UK Hydrographic
Office

New Symbols for Renewable Energy Devices

S-101PT12_6.7

15th Jan 2024

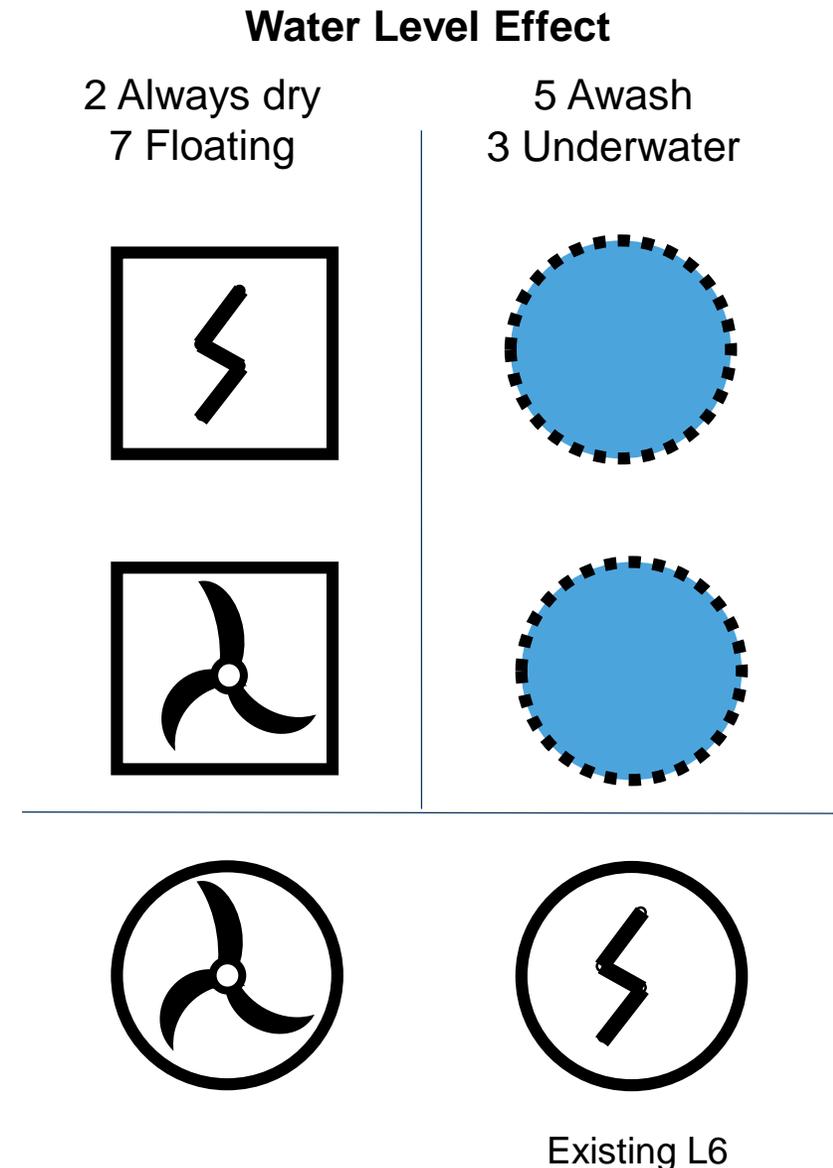
However only Offshore Production area has had a new symbol Assigned based on S-4 L6 (values 2-3-6)
